**CLARKE COUNTY PLANNING COMMISSION
TABLE OF CONTENTS
November 2, 2018 Business Meeting**

SITE PLAN AMENDMENT (SP-18-02)

Re: Handy Mart Diesel Pump Expansion - Site Development Plan
Site Plan and Erosion and Sediment Control Plan Review (1st Submittal)
H&P JN 20181366
Comment Response Letter

Re: Handy Mart Truck Fueling Station Addition
First review comments response

SHEET 3 OF 13

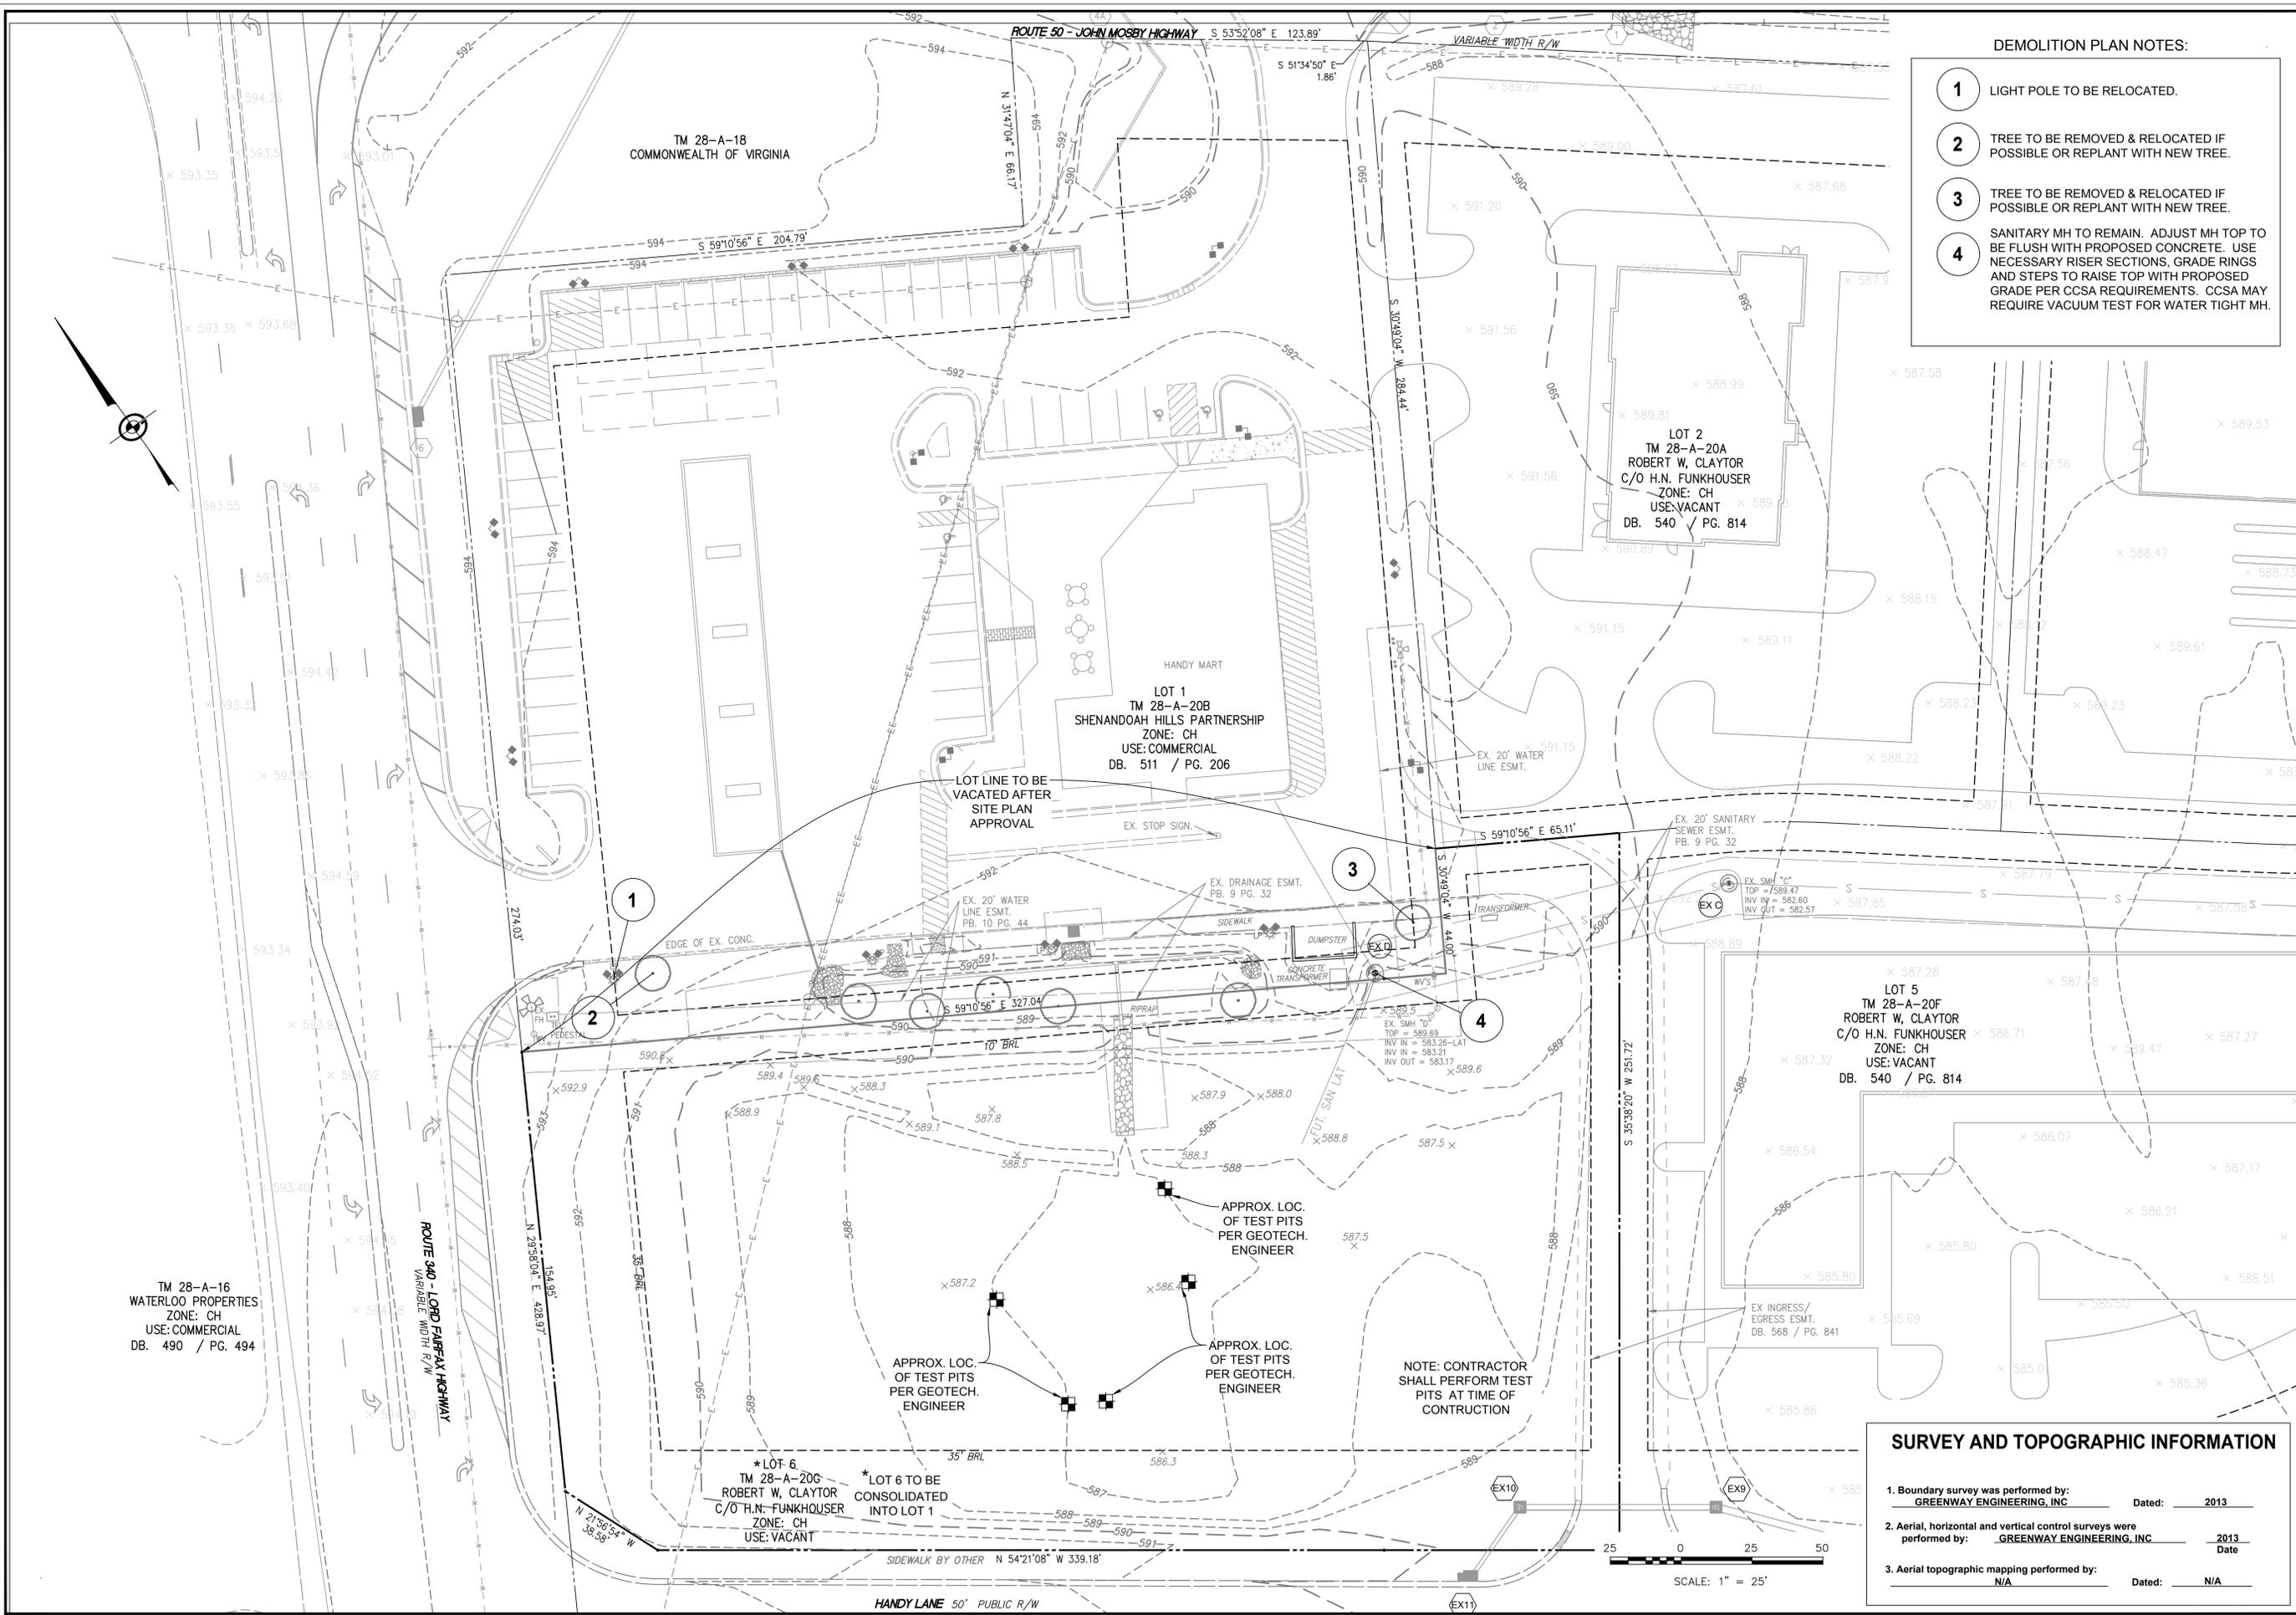
Comment 18: *Sanitary manhole #6 is shown to have the top adjusted to match proposed concrete pavement grade. It appears that the change will result in a difference of more than 2' of height change (upward) on the sanitary sewer manhole top. This amount of change is too much for frame and cover grade rings. Manhole riser sections or a new cone section may be required, along with additional steps. This information should be noted on the site plans. The CCSA may require vacuum testing of the structure after adjustments. It is suggested that the CCSA be allowed to review and comment.*

Response: A note has been added to the plan, "Sanitary MH to remain. Adjust MH top to be flush with proposed concrete. Use necessary riser sections, grade rings and steps to raise top with proposed grade per CCSA requirements. The MH shall be vacuum tested, and a CCSA representative shall be present during the testing." See Sheet #3

SHEET 4 OF 13

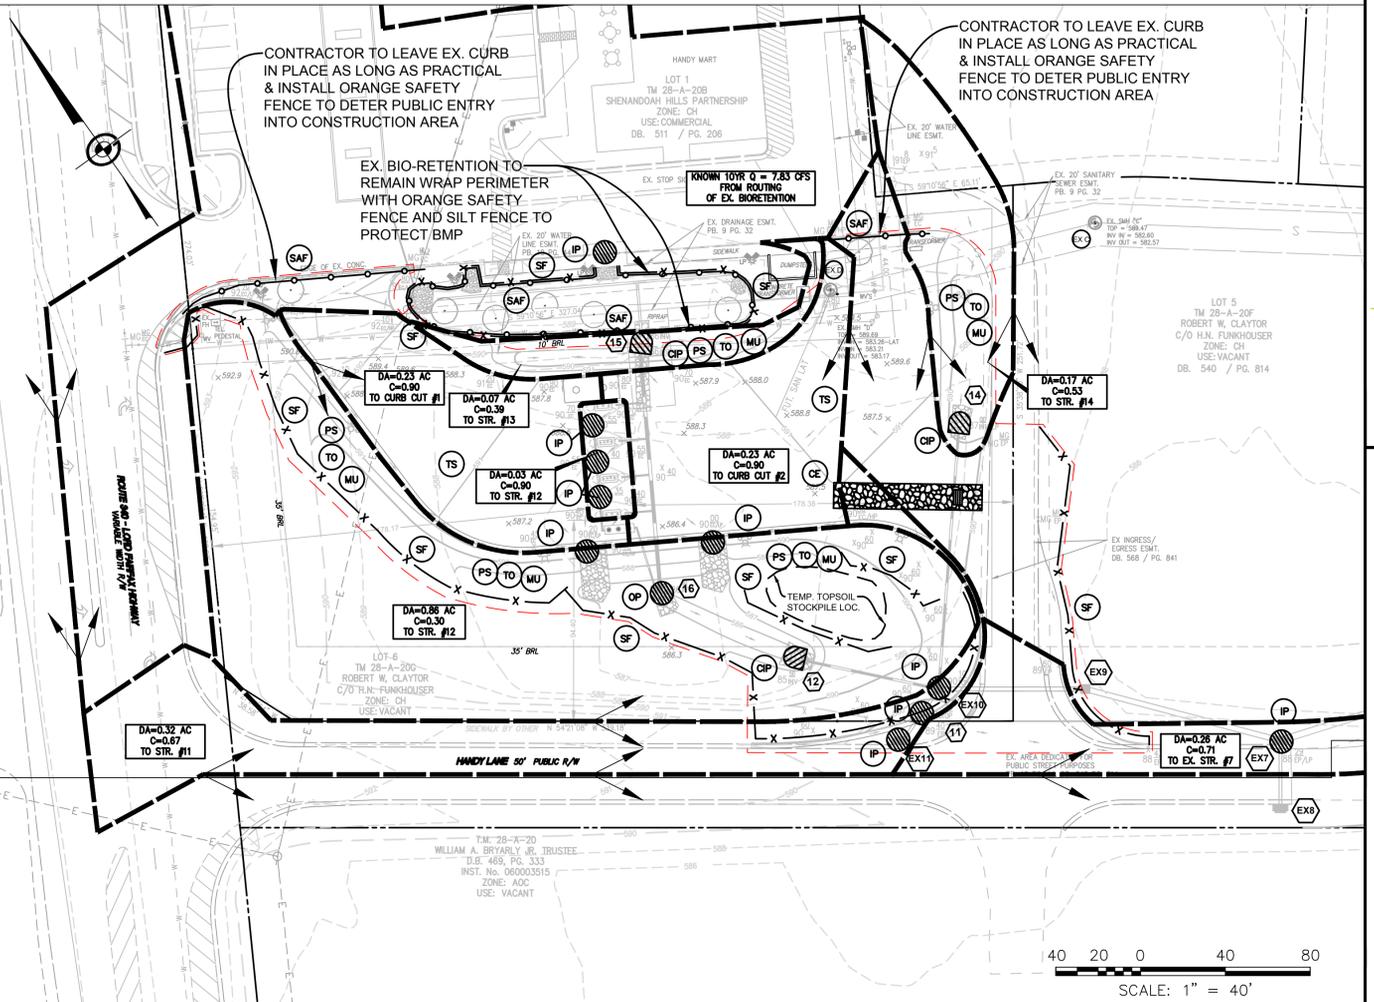
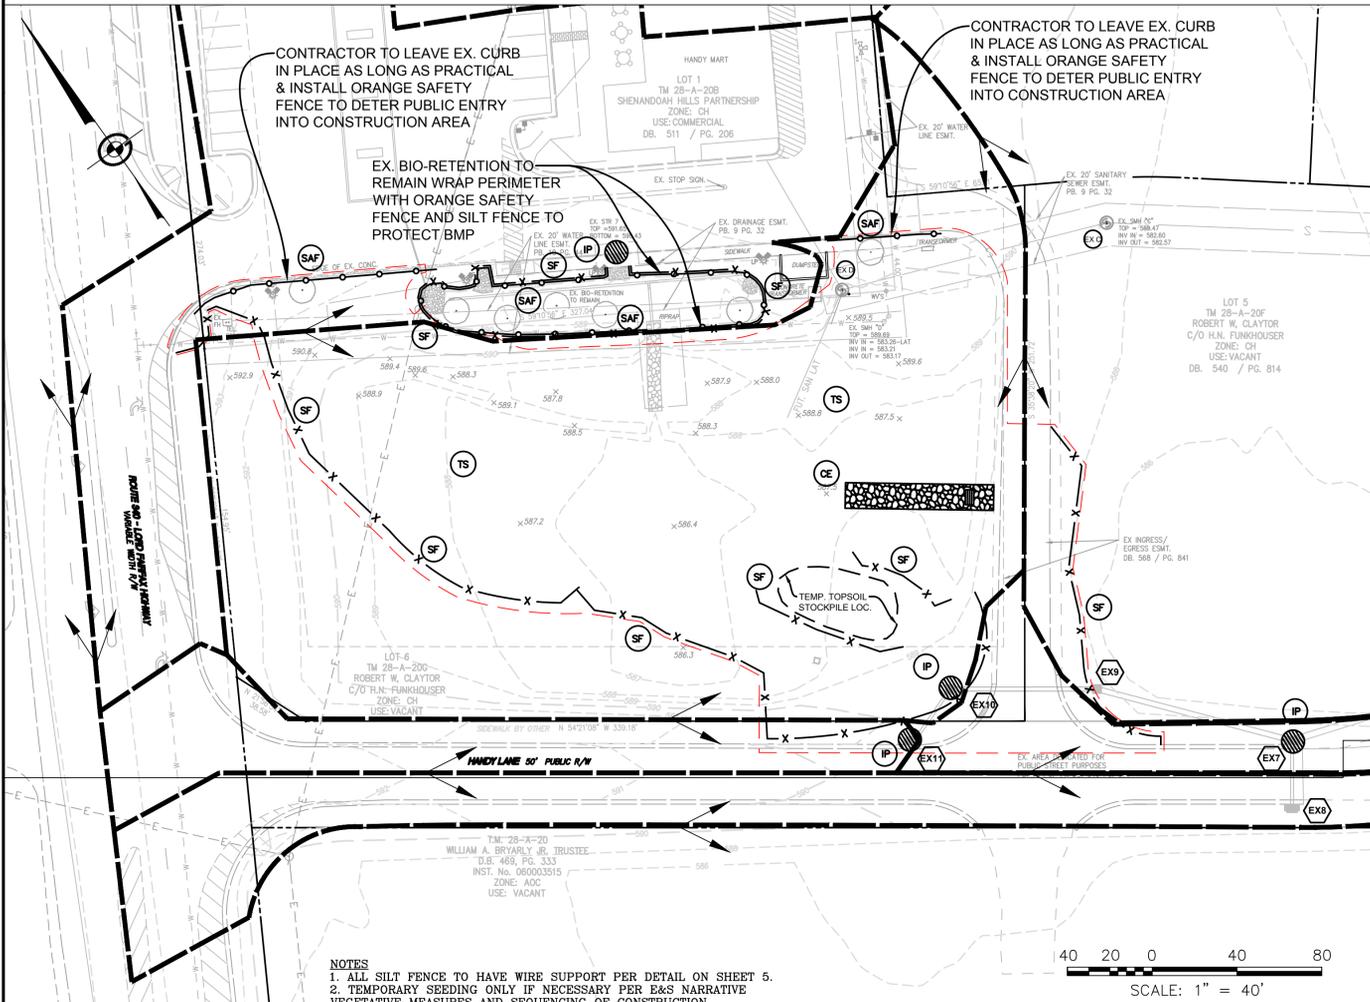
Comment 19: *“Phases of Land Disturbance Activities”, Note #2 references Phase 1 check dams and diversion dikes. None are shown on the plans. Please coordinate and revise the note accordingly.*

Comment 20: *There is in excess of 100 feet of flow length to some sections of proposed silt fence (120 feet +/- in one location). Suggest calling out all silt fences to be wired-reinforced. Also, silt fence is only shown downstream of a portion of the site work. The silt fence should be installed below all disturbed areas, including the storm pipe installation from Structure #12 to Existing Structure #10.*

Comment 21: *Suggest showing inlet protection on existing storm structure EX11 along Handy Lane.*

Comment 22: *A notation related to critical slope is indicated in the ESC Legend. The narrative states that there are no critical areas. Please coordinate and revise the note or narrative accordingly.*

Comment 23: *Suggest showing safety fence (VESCH Standard and Specification 3.01) around entire perimeter of the existing bioretention facility. Also, the silt fence should extend around the perimeter of the facility.*

Comment 24: *No ESC measures are shown in or below the proposed ditch construction between Structures #16 and #12.*

Comment 26: *Mulching (VESCH Standard & Specification 3.35), Topsoiling (VESCH Standard & Specification 3.30), and Temporary Seeding (VESCH Standard & Specification 3.31), are not shown in the ESC Legend or on the ESC Plans. These measures are discussed in the ESC Narrative, but must also be shown.*

Comment 27: *ESC measure callout for Structures #13 and #14 should be Culvert Inlet Protection.*

Comment 28: Consider leaving existing curb in place across proposed entry locations until site grading is complete.

Response: Check dams and diversion dikes have been deleted from the Note #2.

Response: A note has been added for all silt fence to be wired-reinforced. Structure #12 is a sump (low point) and the surround area is higher. We have added silt fence as requested along the perimeter of LOD near structure #12.

Response: Inlet protection has been added to existing storm structure EX11 as requested.

Response: The notation for critical slope has been removed from the ESC Legend.

Response: Orange Safety Fence (Spec 3.01) and silt fence has been added to wrap the perimeter of the existing bioretention facility, see sheet 4.

Response: Silt fence has been added to the southern LOD as requested.

Response: The ESC Legend and ESC Plans have been updated to show mulching, topsoiling and temporary seeding, see sheet 4.

Response: Inlet protection callout has been changed to Culvert Inlet Protection at storm structures #14 & #15, see sheet 4.

Response: A note has been added to leave existing curb in place as long as practical to deter public entry into construction site and to add orange safety fence, see plan label on sheet 4.

SHEET 9 OF 13

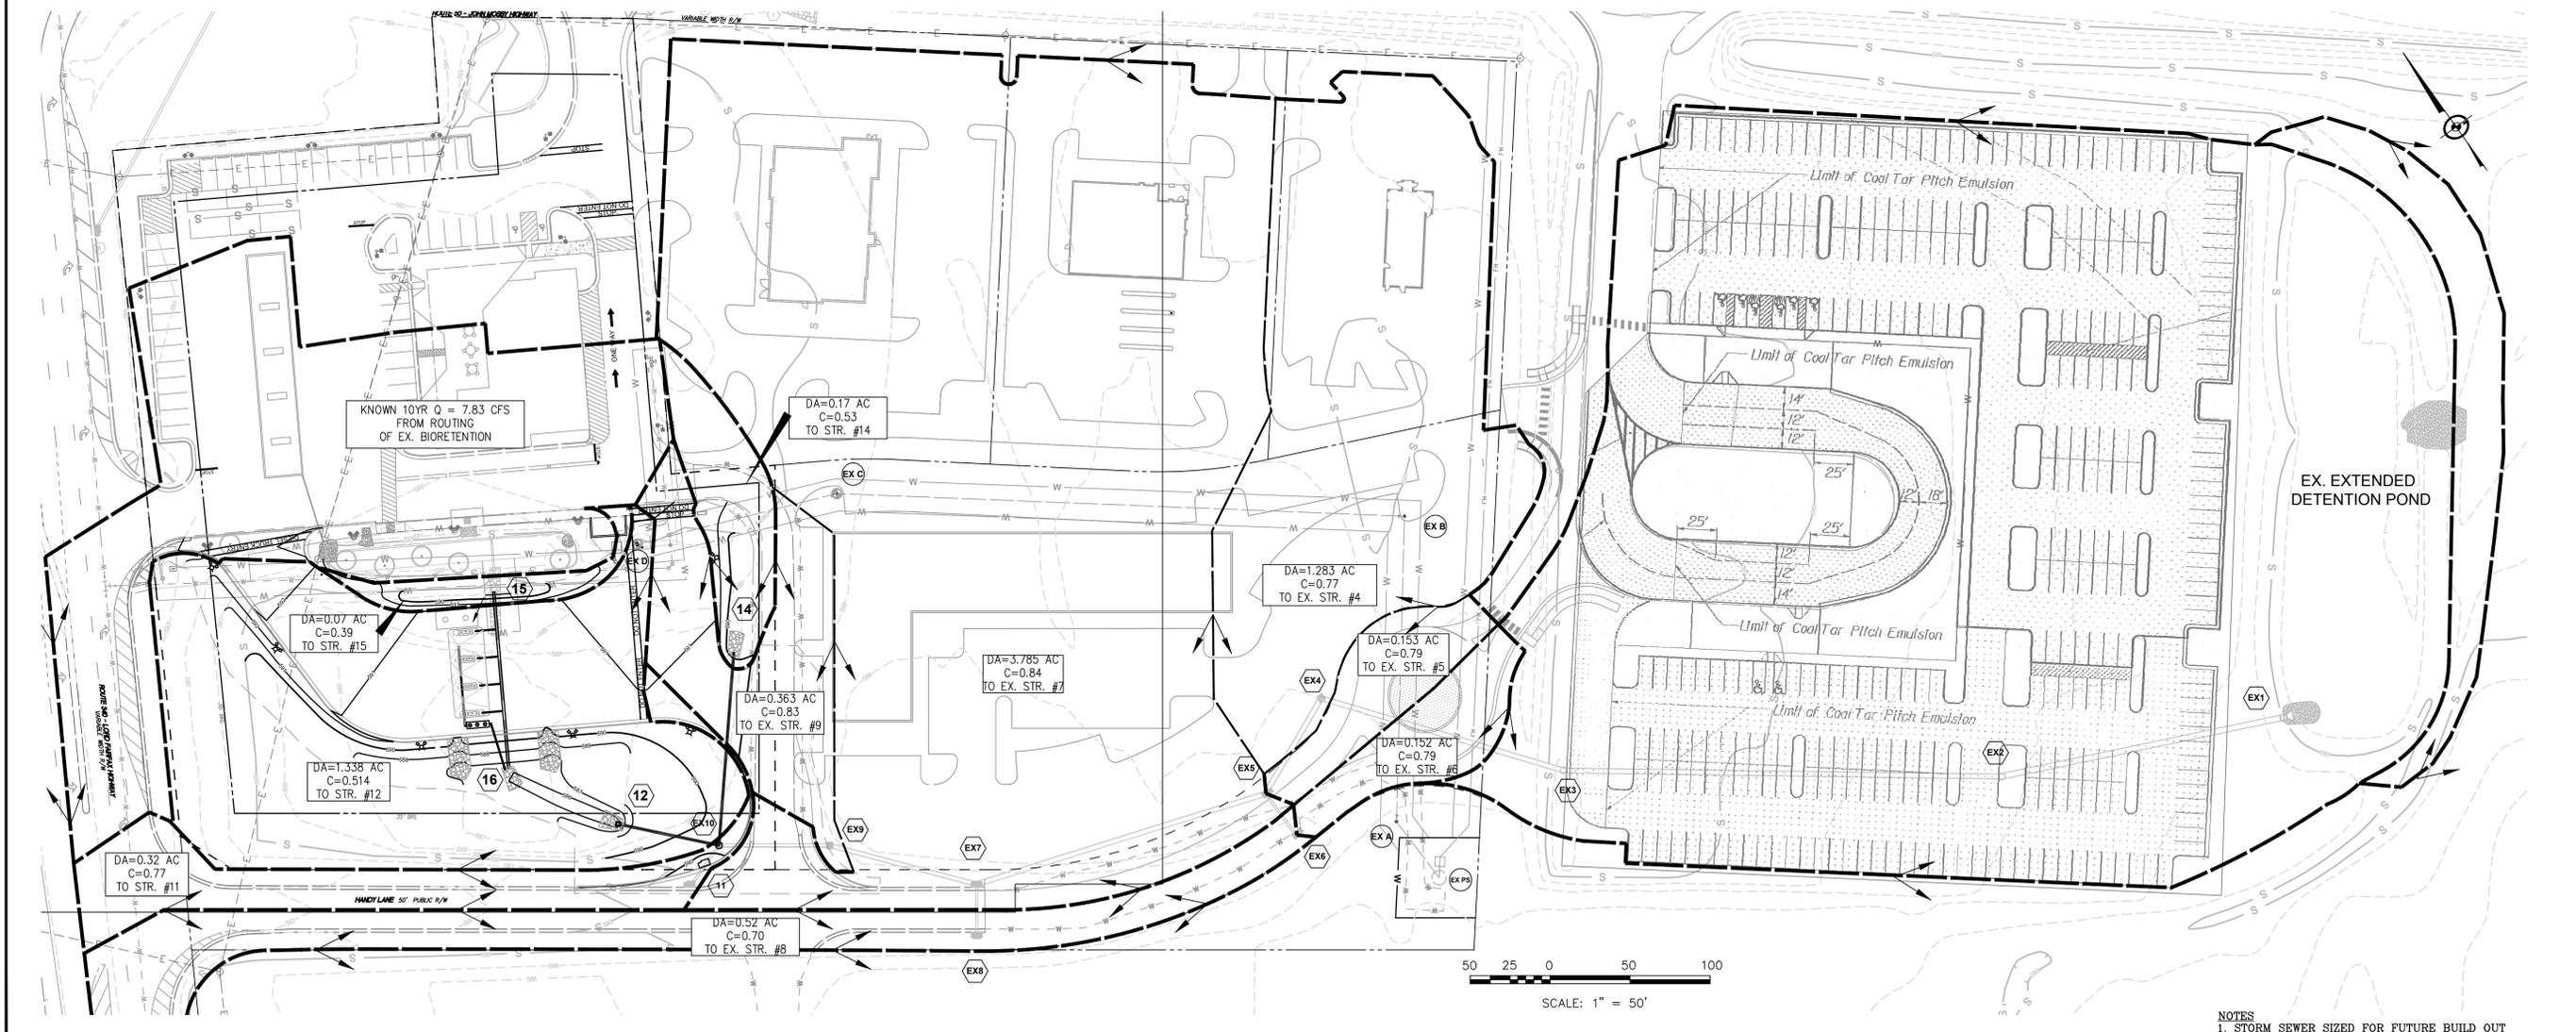
Comment 37: *Will manhole section of Existing Structure #10 accommodate the two additional proposed storm pipes without modification or replacement of the existing structure? Please provide information showing where this has been verified.*

Comment 38: *Please provide map showing drainage areas to inlets and culverts to accompany storm inlet and storm sewer calculations.*

Response: We adjusted the alignment of proposed storm pipe from structure #12 to Ex #10 to provide minimum angle between pipes entering a round 4' structure. Attached is a minimum pipe angle chart for 48" manhole to demonstrate accommodation of the proposed pipes. Also, upon review it was determined that the top would have to change to accommodate the future sidewalk by others. The top is now proposed to be a manhole top instead of a DI top. See updated storm sewer profile sheet 9 & site plan sheet 6.

Response: Drainage areas have been added to sheet 9.
